ZONING BOARD OF APPEALS MEETING

LOCATION: TOWNSHIP ANNEX, 7527 HIGHLAND ROAD, WHITE LAKE, MICHIGAN, 48383 (FORMER WHITE LAKE LIBRARY)
THURSDAY, MARCH 24, 2022 – 7:00 PM

AGENDA

-329-013 & 035 ORMOND ROAD GRANT WARD SURVEYORS

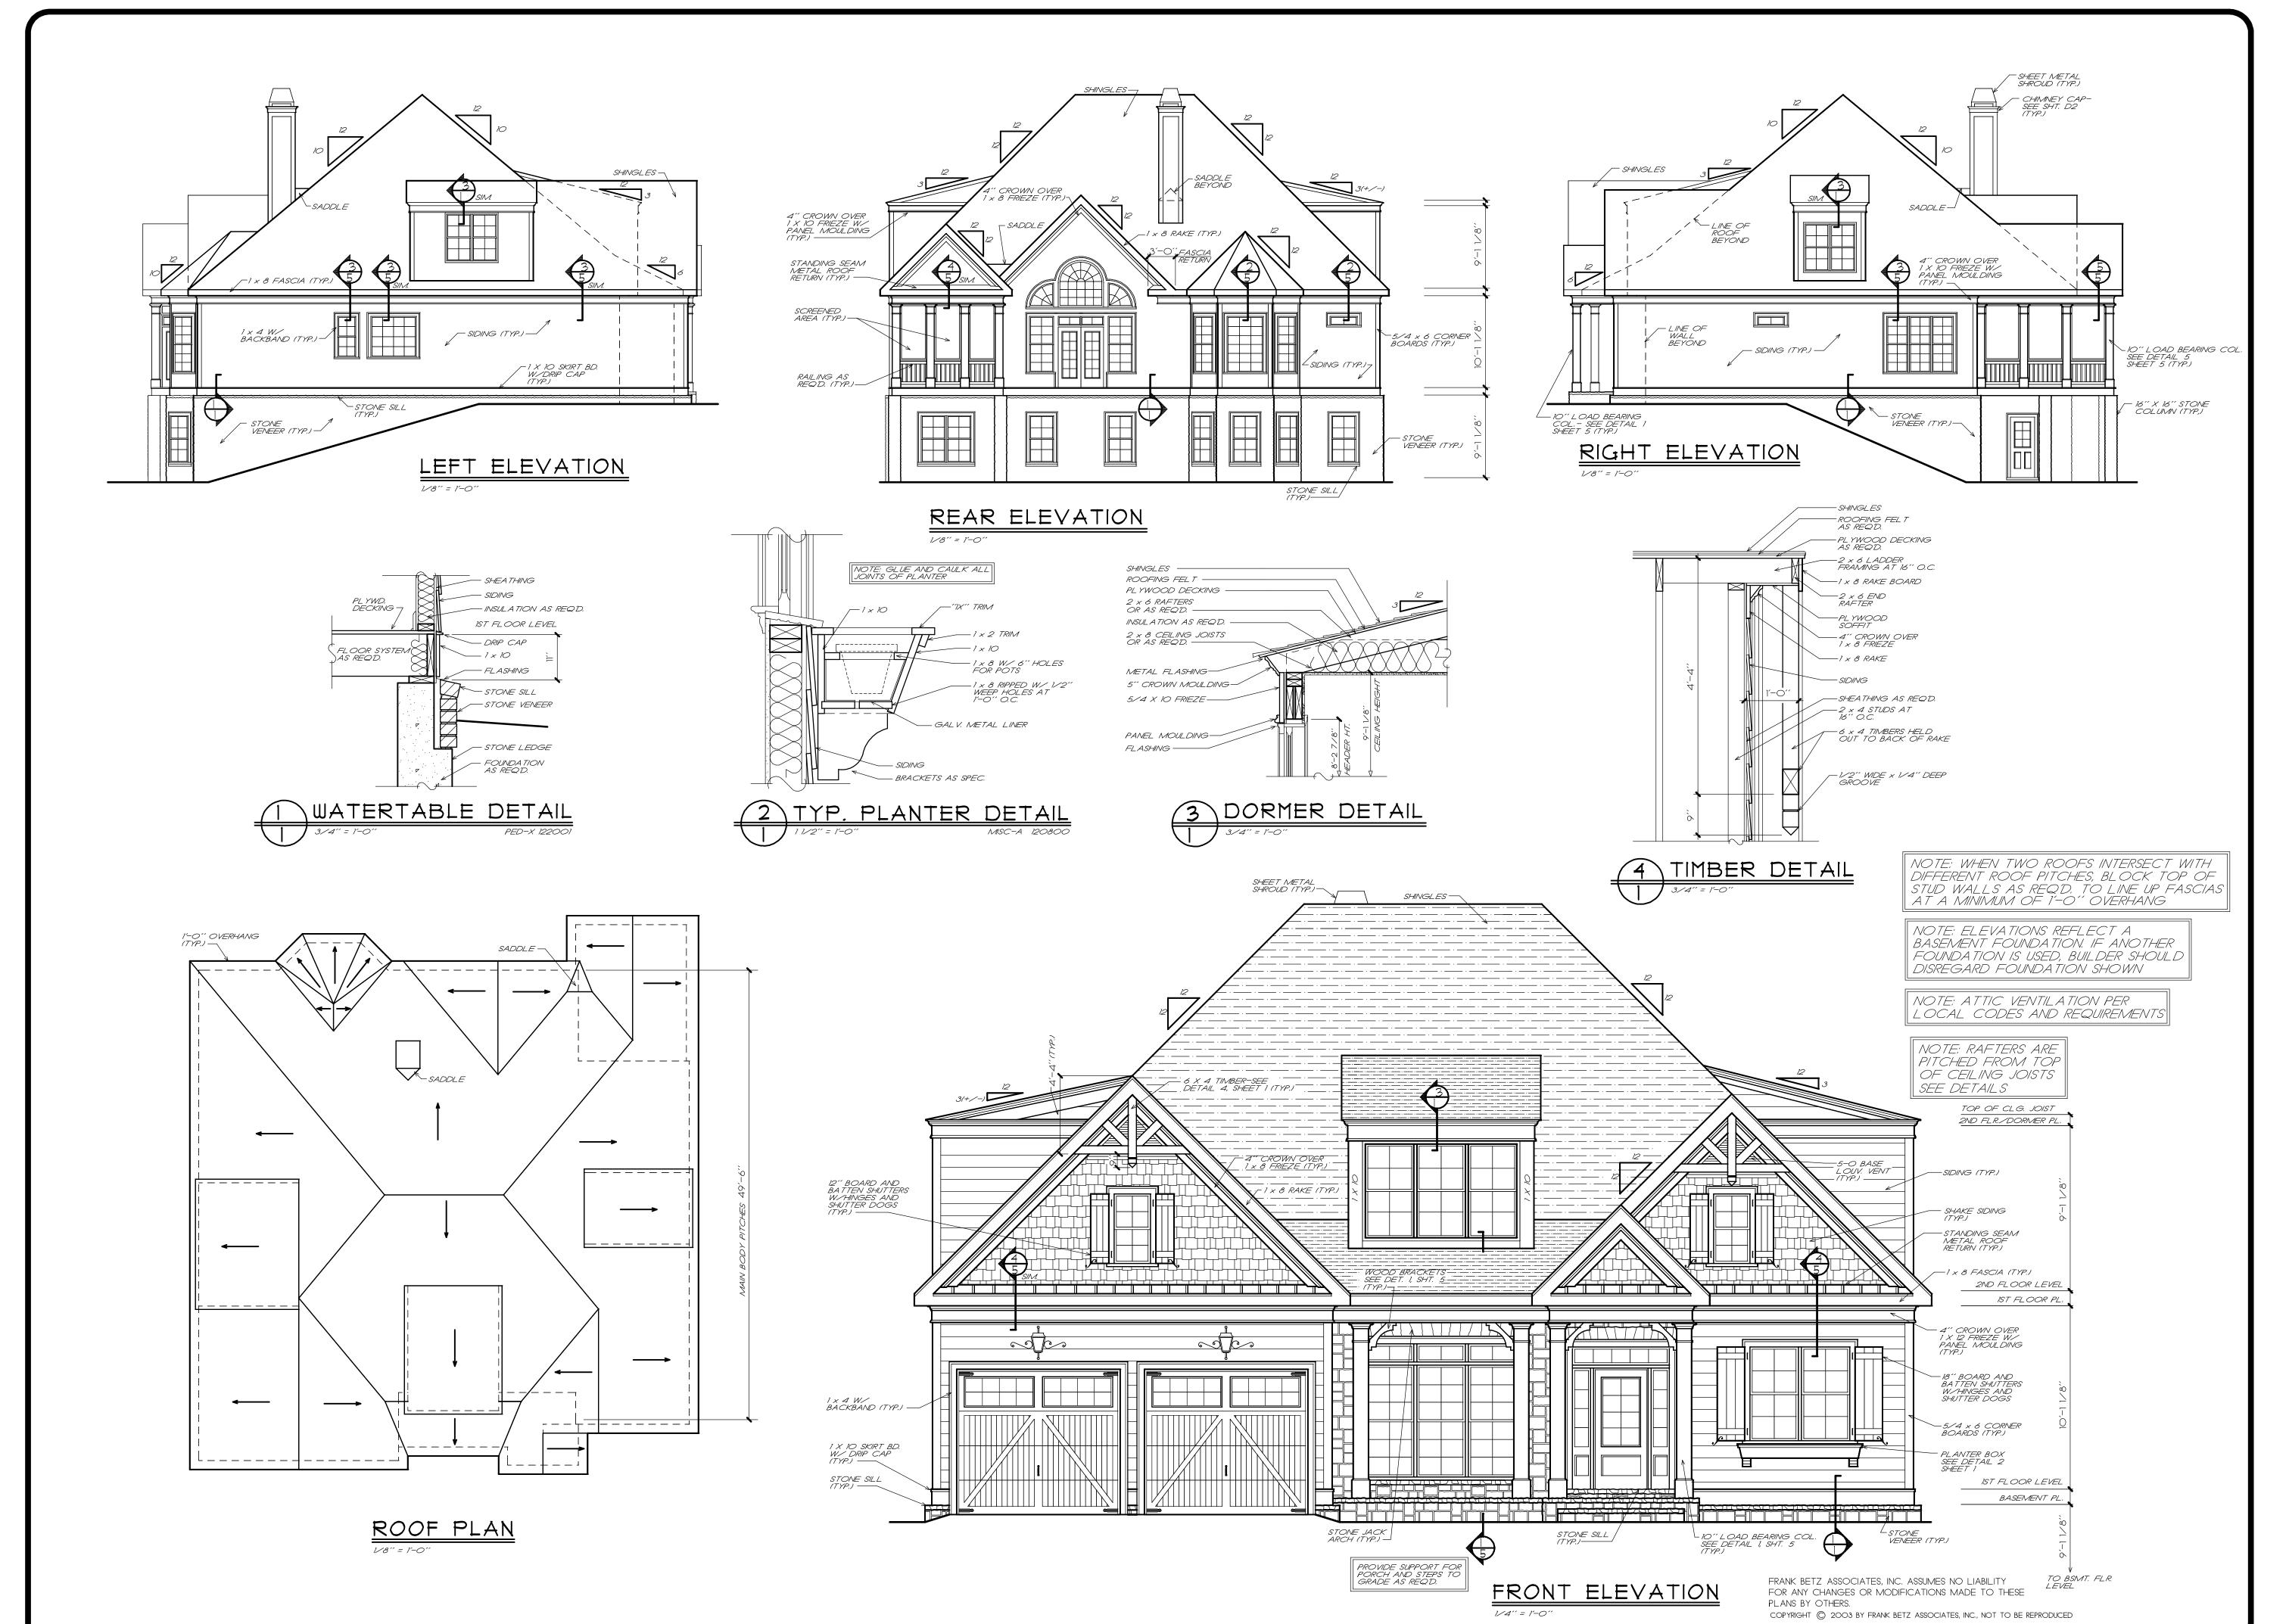
As indicated on the site plan, the proposed house footprint is 2,438 square feet in size (the garage area is 506 square feet). The submitted architectural information is inconsistent with the site plan. The house plan details state the first-floor area is 2,123 square feet, the second-floor area is 878 square feet, and the garage area is 506 square feet (total: 3,507 square feet). Based on the house details, the footprint of the building is 2,629 square feet (191 square feet larger than indicated on the site plan).

According to the site plan, the house at its closest point would be located 13.1 feet from the front lot line, requiring a variance of 21.9 feet from the required 35-foot front yard setback. A variance to address the lot area nonconformity is also requested. According to the plan, the parcels (if combined) would contain 0.343-acre (14,923 square feet) in area. In the R1-C zoning district the minimum lot size requirement is 16,000 square feet.

While rear yard setback and lot coverage variances were published as a request (based on an initial plan submitted), the latest plan indicates such variances are not needed.

- The Applicant shall obtain all necessary approvals from the Oakland County Health Division prior to issuance of a building permit.
- The Applicant shall obtain all necessary permits from the White Lake Township Building Department.
- Prior to issuance of a building permit, a demolition permit shall be obtained from the Township to remove the existing buildings and structures from the subject parcels.
- No mechanical units, including HVAC system or generator, shall be placed closer than five (5) feet to any side yard lot line.
- A foundation certificate shall be required prior to the backfill inspection by the Building Department.
- An as-built survey shall be required to verify the approved setbacks.
- The subject parcels shall be combined prior to issuance of a building permit.
- Revised plans shall be submitted to meet requirements of the Building Official.

- REQUEST AS FOLLOWS
- A) NORTH SIDE YARD TO 1.6' VARIANCE
- B) SOUTH SIDE YARD TO 1.4' VARIANCE
- 2) ALSO LOT SIZE VARIANCE:

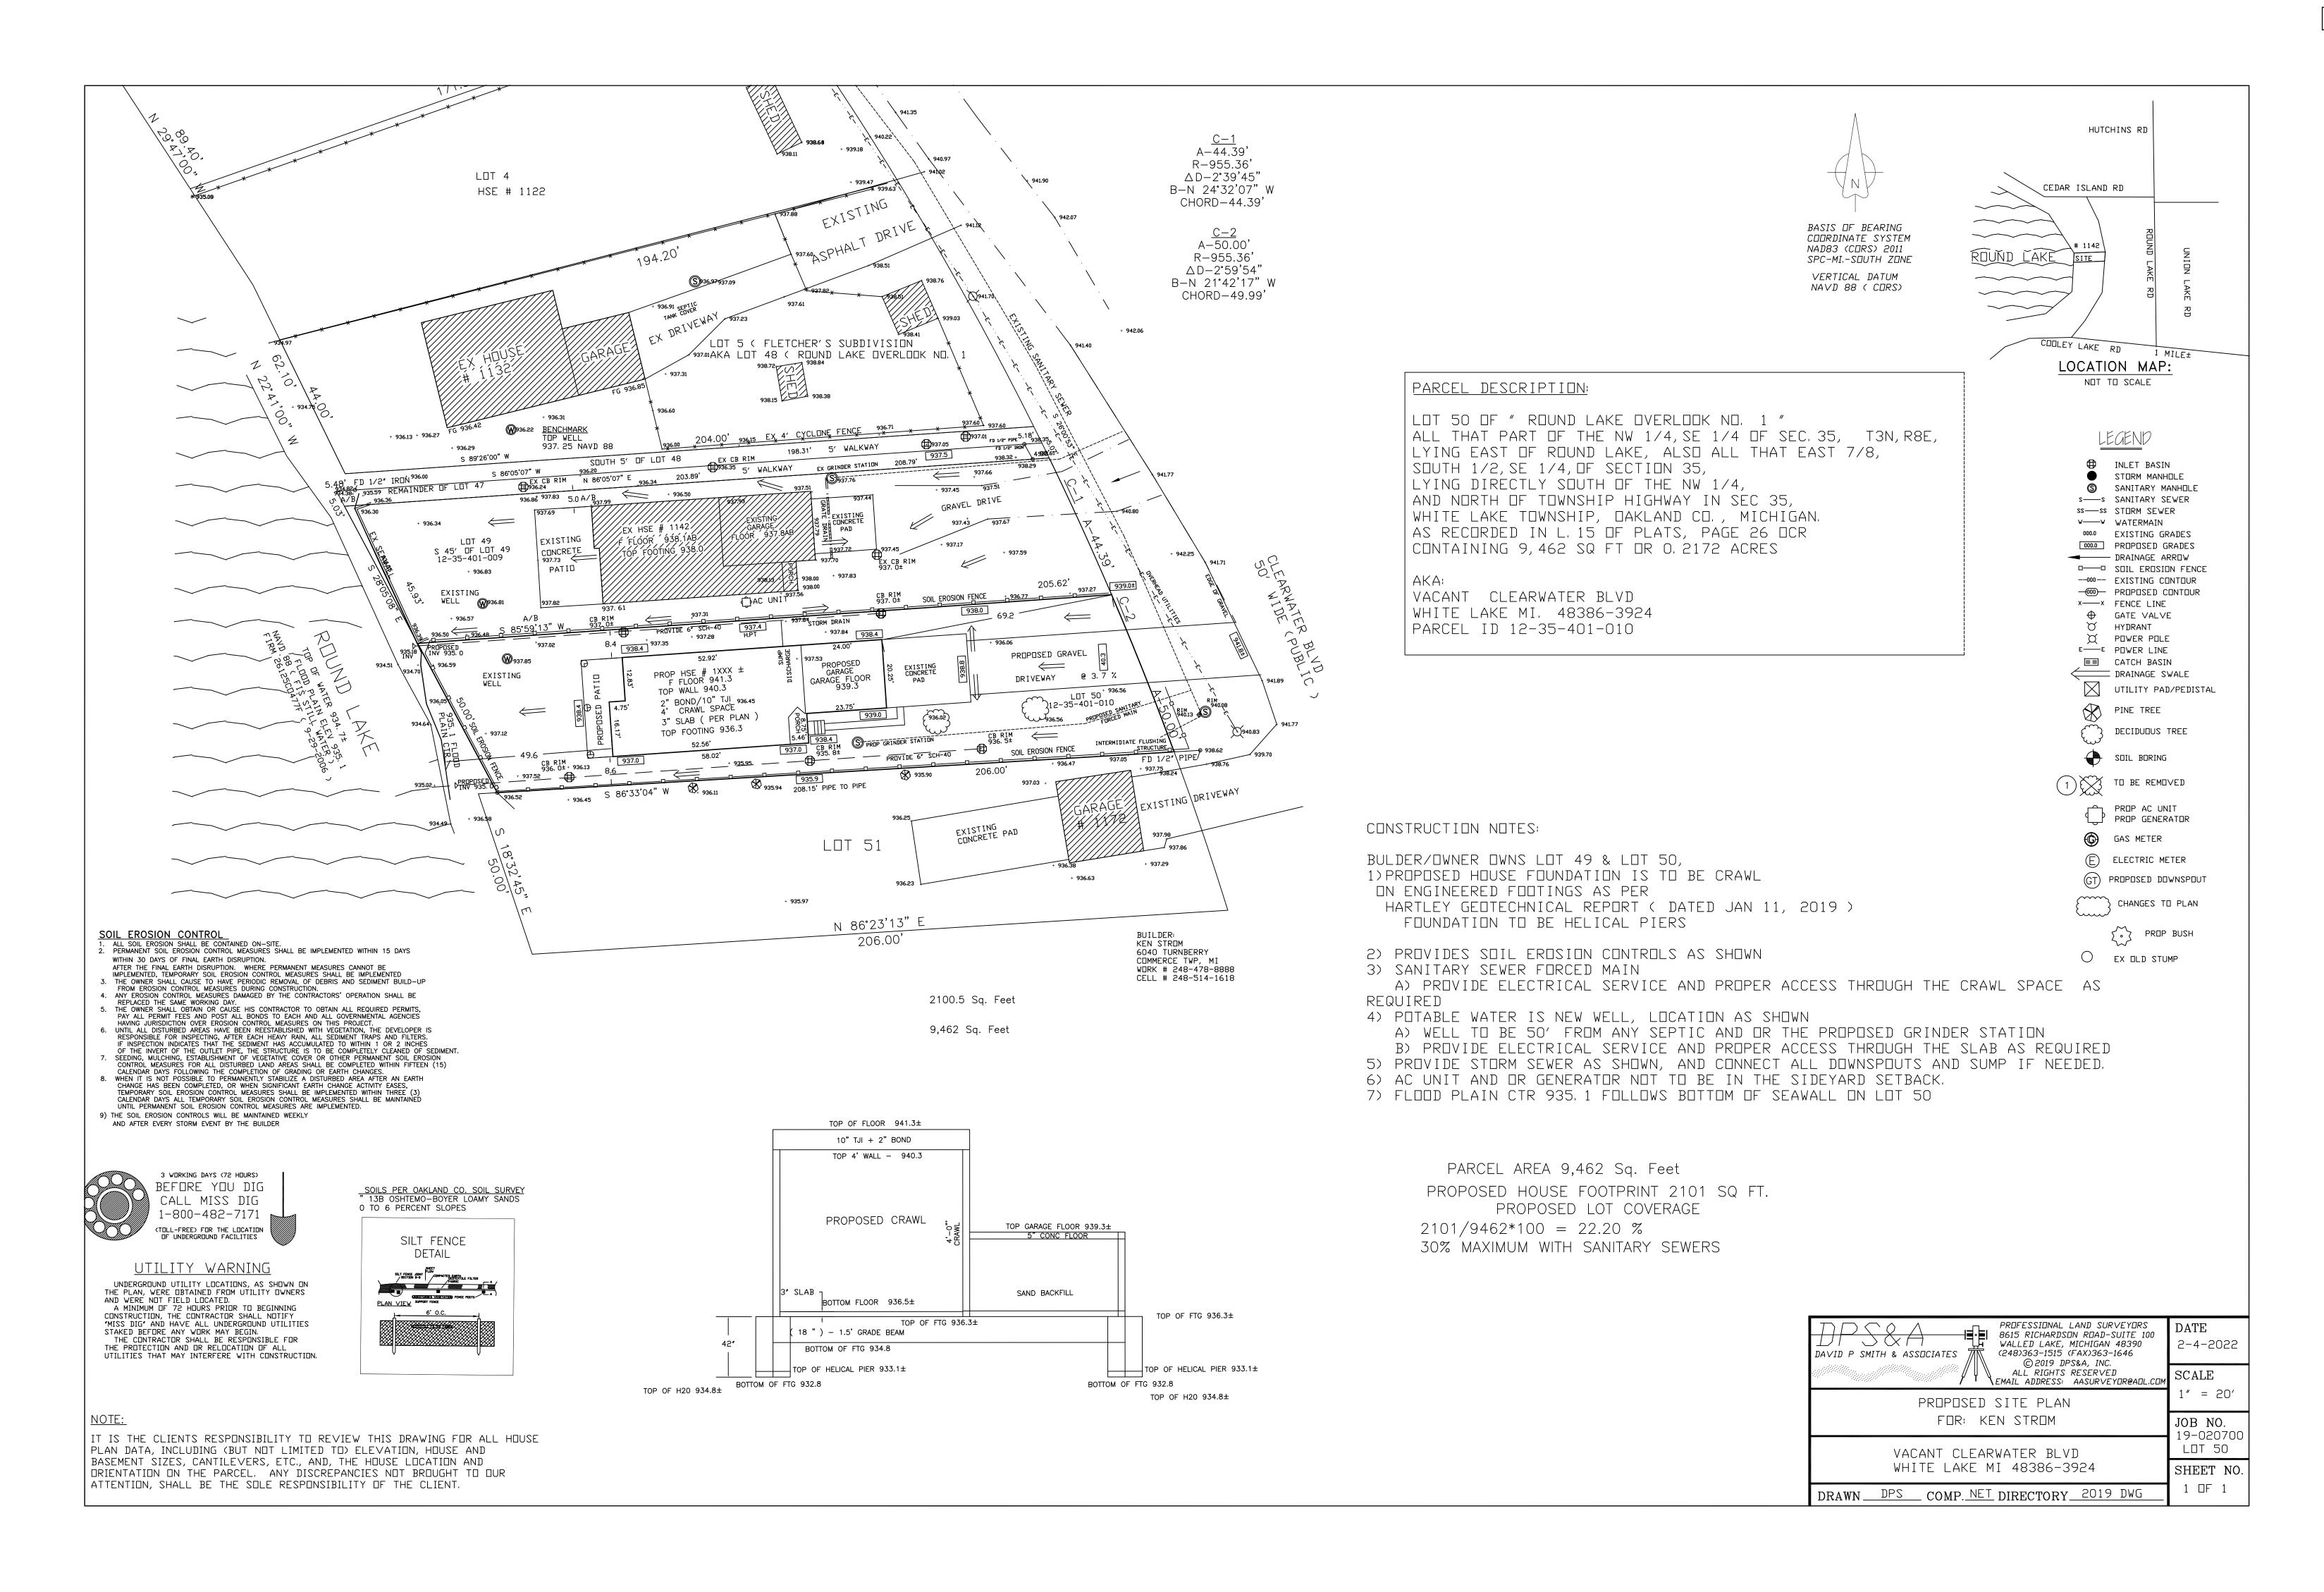
Based on the submitted architectural plans, the proposed house is 3,158 square feet in size (first floor: 1,544 square feet; second floor: 1,134 square feet; garage: 480 square feet). According to the submitted site plan, the proposed lot coverage is 22.2% (2,101 square feet), which is 2.2% (208.6 square feet) beyond the allowable limit (1,892.4 square feet). As proposed, the house would be located 8.4 feet from the north side lot line and 8.6 feet from the south side lot line, requiring variances from the 10-foot side yard setback. Variances to address the lot area and lot width nonconformities are also requested.

- The Applicant shall obtain all necessary permits from the White Lake Township Building Department.
- No mechanical units, including HVAC system or generator, shall be placed closer than five (5) feet to any side yard lot line.
- A foundation certificate shall be required prior to the backfill inspection by the Building Department.
- An as-built survey shall be required to verify the approved setbacks and lot coverage.
